INDIANA UTILITY REGULATORY COMMISSION

RESPONSE OF
NORTHERN INDIANA PUBLIC SERVICE COMPANY
TO THE DRAFT REPORT
OF THE INDIANA UTILITY REGULATORY COMMISSION
DATED MARCH 3, 2015

NIPSCO's Response to the IURC's Draft Report
Regarding NIPSCO's 2014 IRP

Request 1-12:

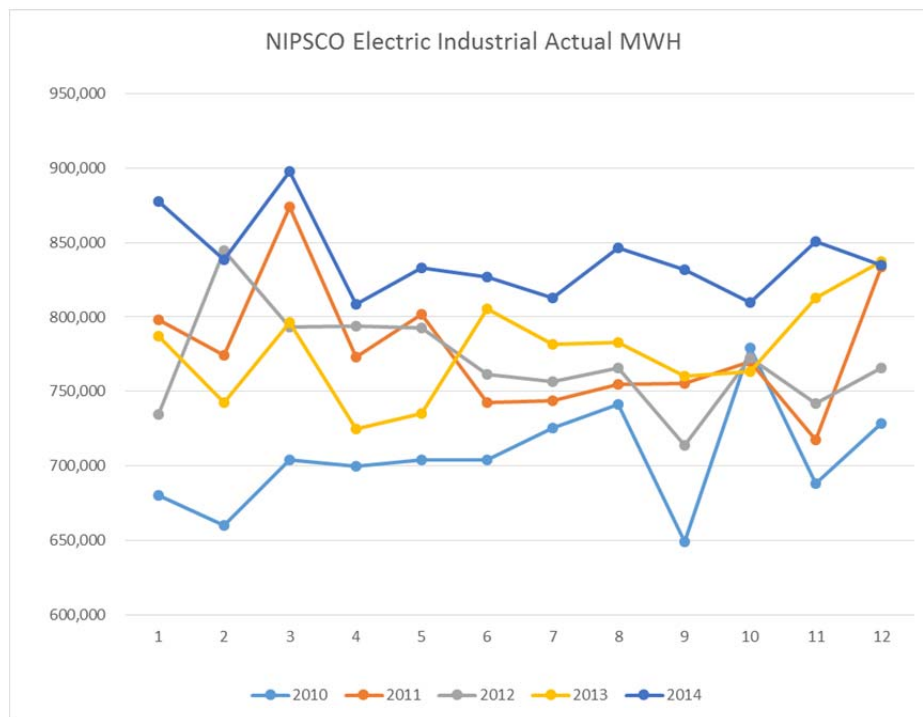
NIPSCO produces weather normalized historical energy for residential and commercial customers only. NIPSCO does not produce one for industrial customers because, according to NIPSCO, *"industrial varies very little with weather."* While this may be correct, the Commission staff would like to know if NIPSCO has done an objective analysis of whether industrial loads are affected by temperature and humidity. The Commission staff would be surprised if there was no affect. Regardless, for credibility, the Commission staff believes it would be appropriate to weather normalize.

While NIPSCO has not done an analysis regarding the impact of temperature and humidity on industrial load, the accompanying graph shows the monthly industrial load for 2010-2014. With no compelling seasonal pattern, NIPSCO does not normalize this load.
